**DRAFT PROPOSAL FOR AMENDMENTS TO REGULATION No. 48**

(Installation of lighting and light-signalling devices)

*Transmitted by the experts from Germany and the Netherlands*

##### Model A

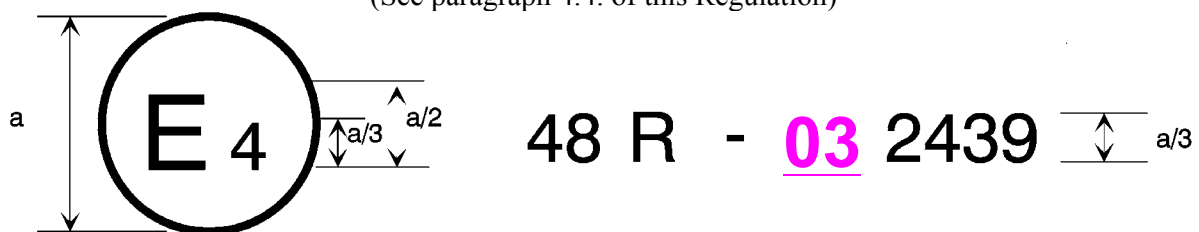
The above approval mark affixed to a vehicle shows that the vehicle type concerned has, with regard to the installation of lighting and light-signalling devices, been approved in the Netherlands (E4) pursuant to Regulation No. 48 as amended by the 02 03 series of amendments. The approval number indicates that the approval was granted in accordance with the requirements of Regulation No. 48 as amended by the 02 03 series of amendments.

Model B

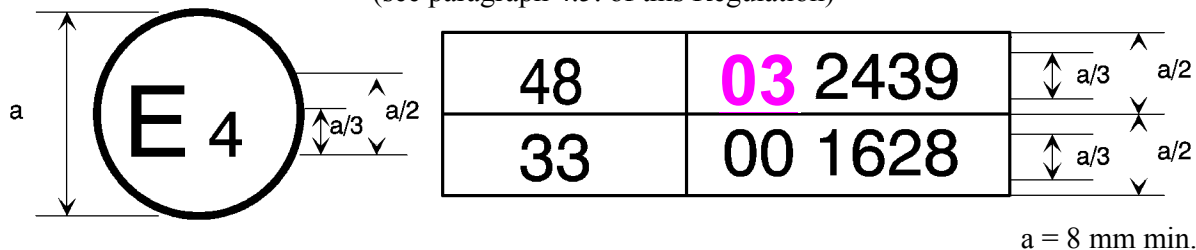
The above approval mark affixed to a vehicle shows that the vehicle type concerned has been approved in the Netherlands (E4) pursuant to Regulation No. 48 as amended by the 02 03 series of amendments and Regulation No. 33. <sup>1/</sup> The approval number indicates that, at the dates when the respective approvals were given, Regulation No. 48 was amended by the 02 03 series of amendments and Regulation No. 33 was still in its original form.
